BLOCK 41 + BLOCK 44 APARTMENTS

DR HEARING 02 | August 17th, 2017

NE FUTURE CONVERSION SPACE

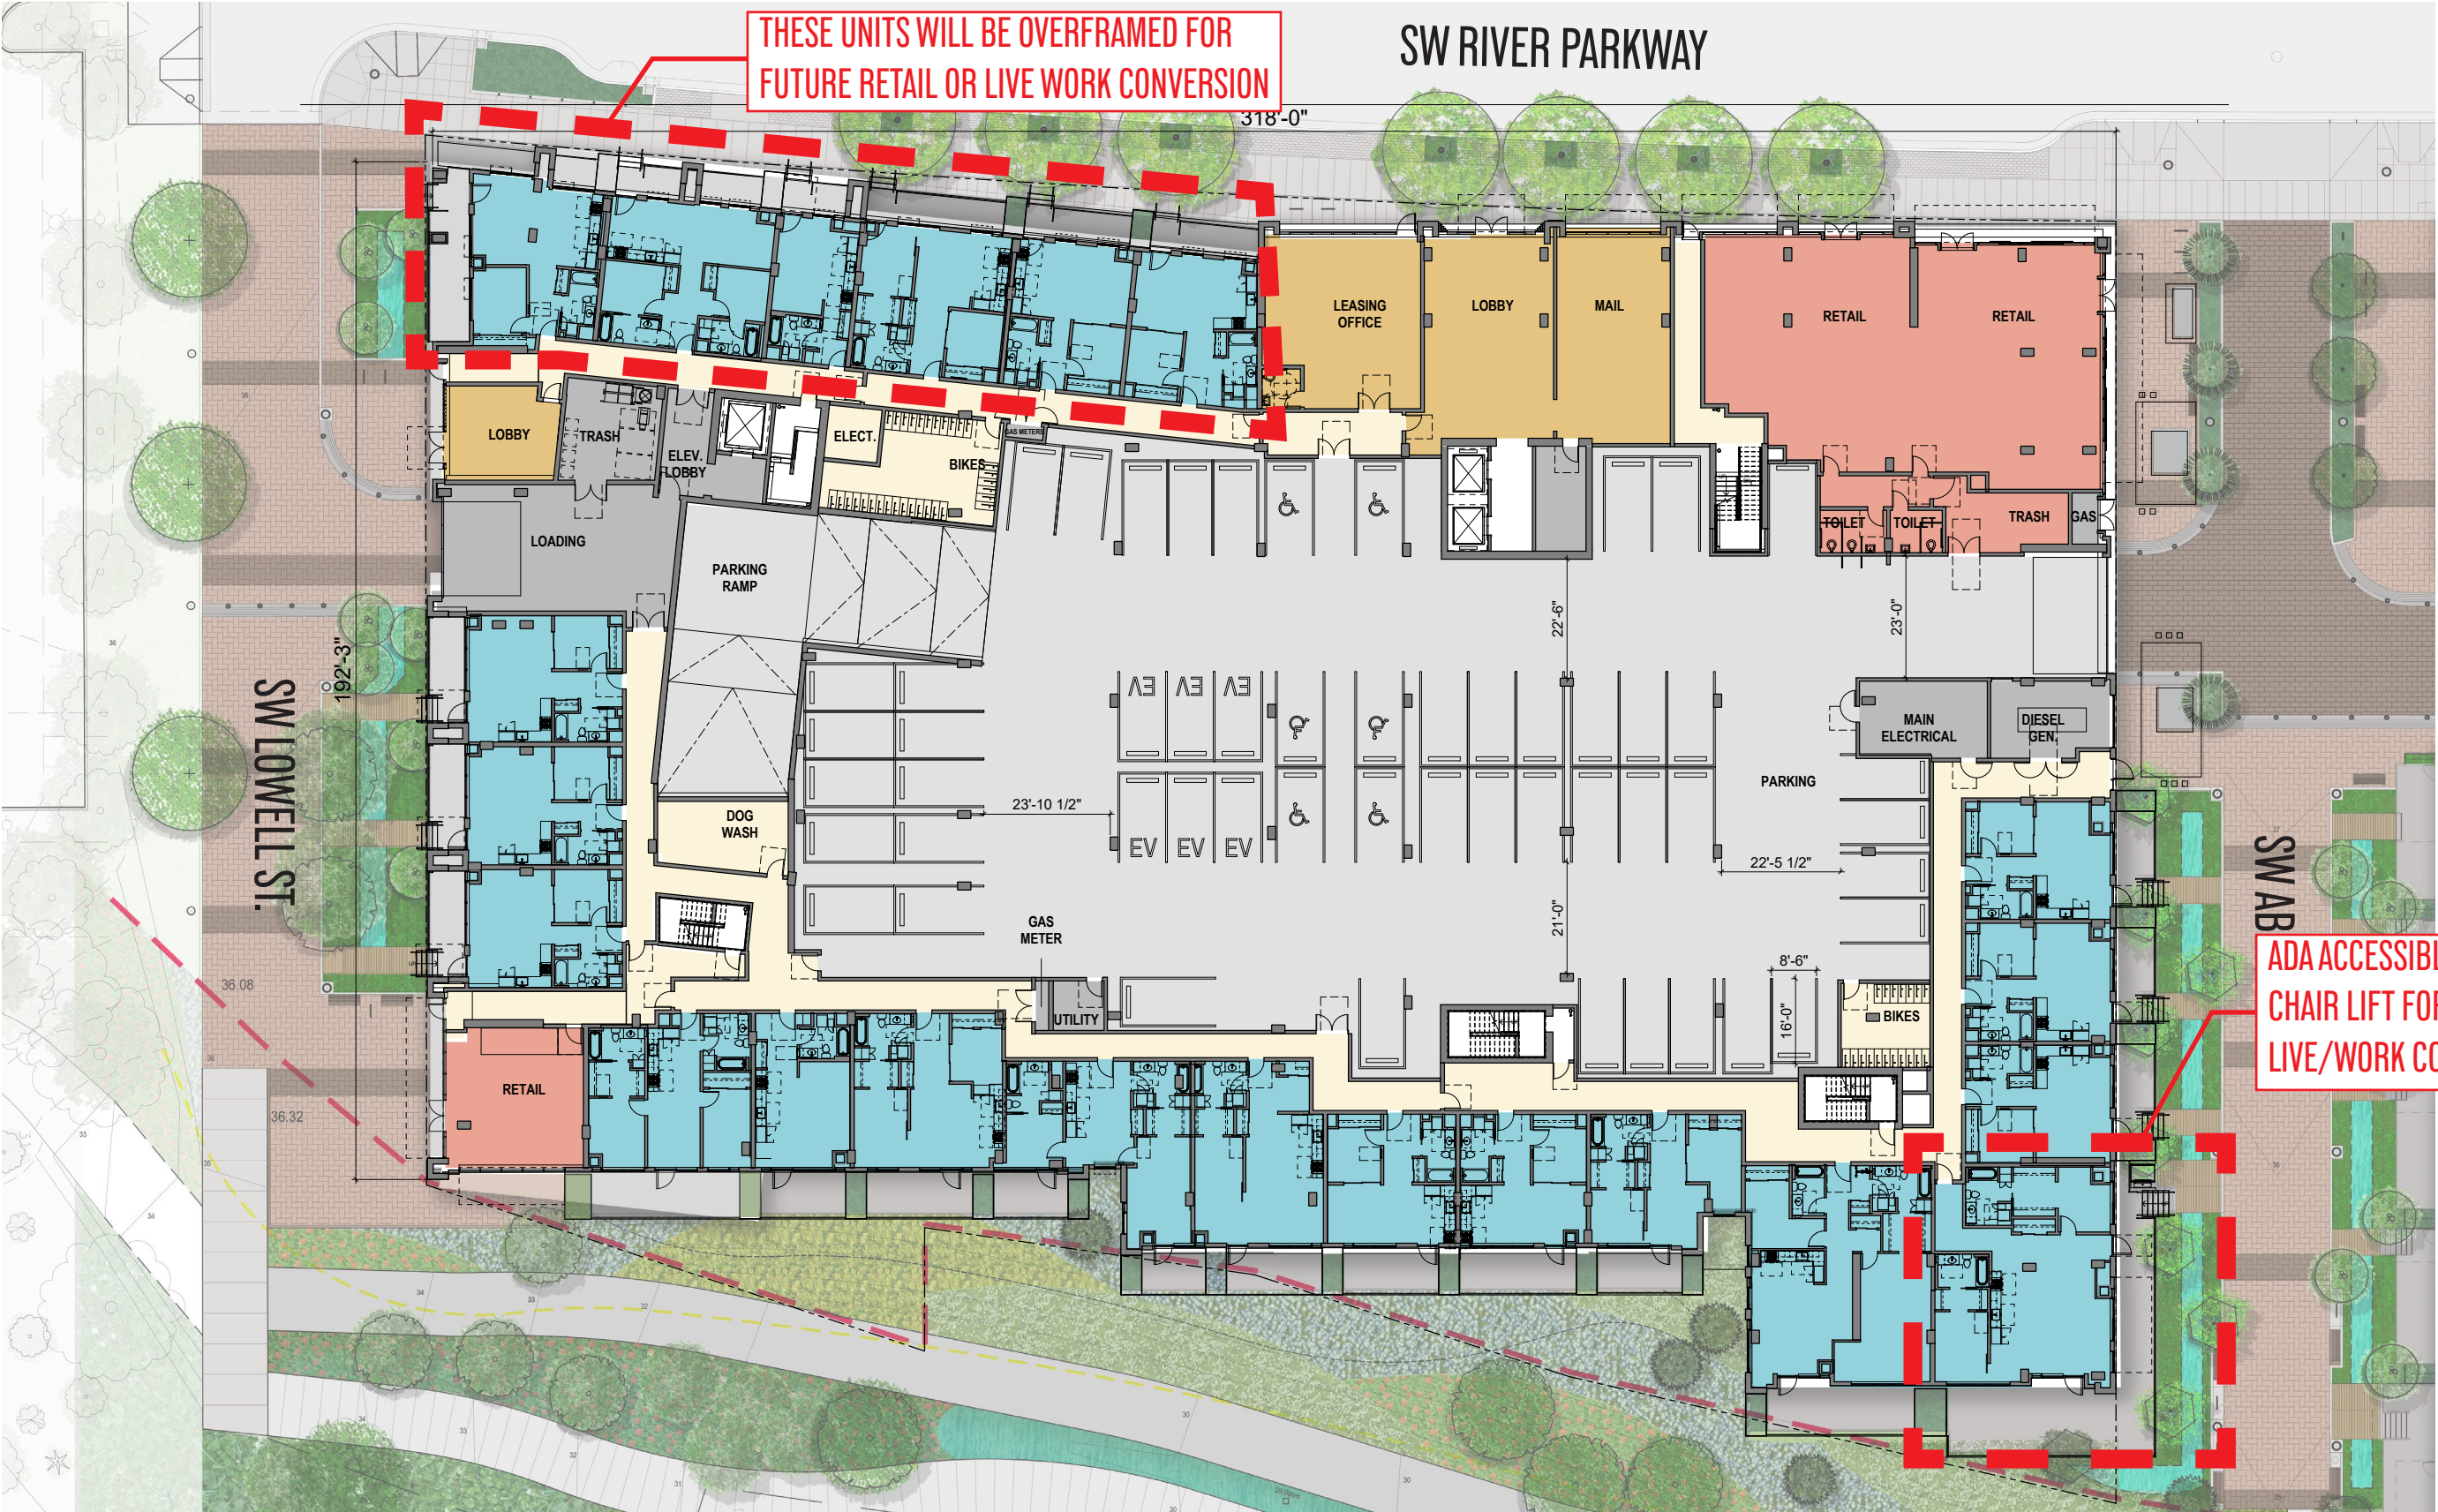
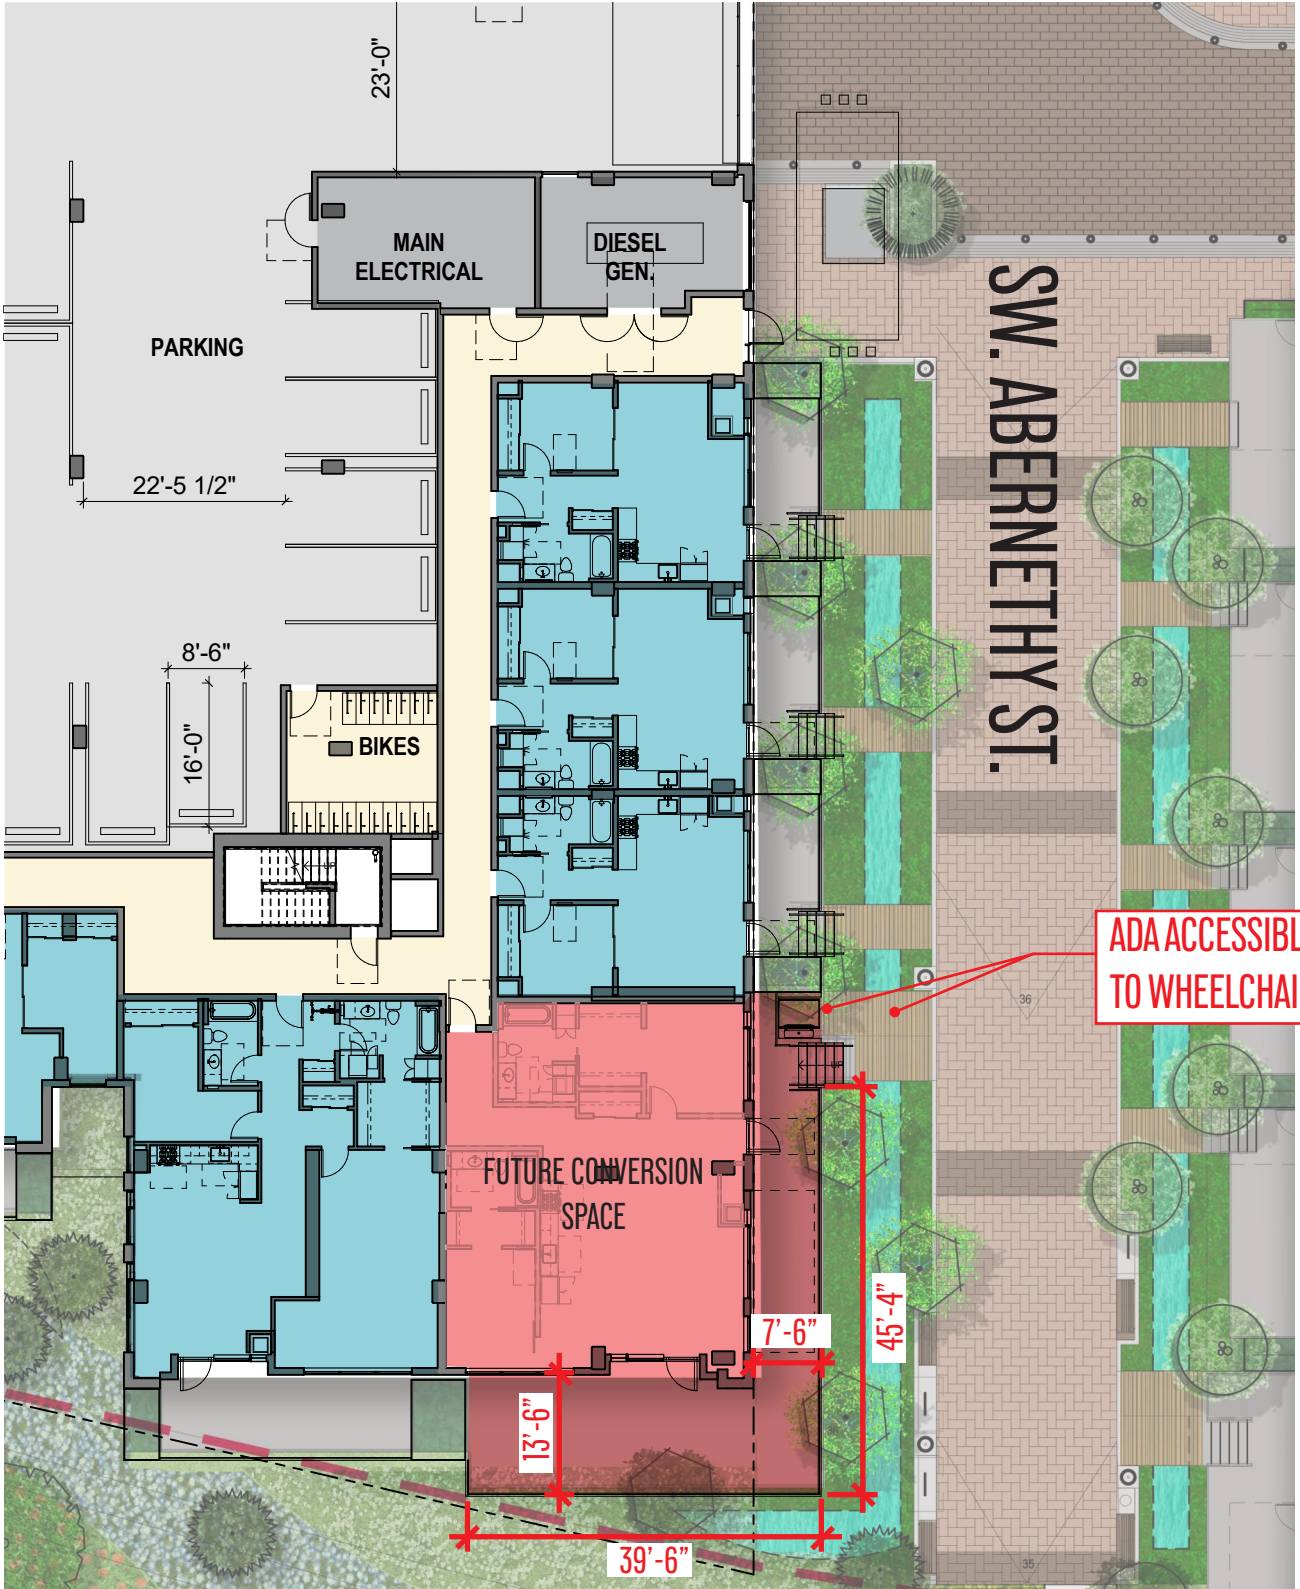
1. Simplify Massing, Especially Along River Parkway
2. Ribbon Language Along River Seem Incongruent with other Building Vocabulary
3. Simplify Window Patterning in Brick Masses
4. Add More Commercial or Live/Work Conversion Space Along River

- Wrap Around Dock/Porch at NE Corner with Block-out for Future Wheelchair Lift. Units along River Parkway are Over-Framed and can be Removed for Future Conversion.
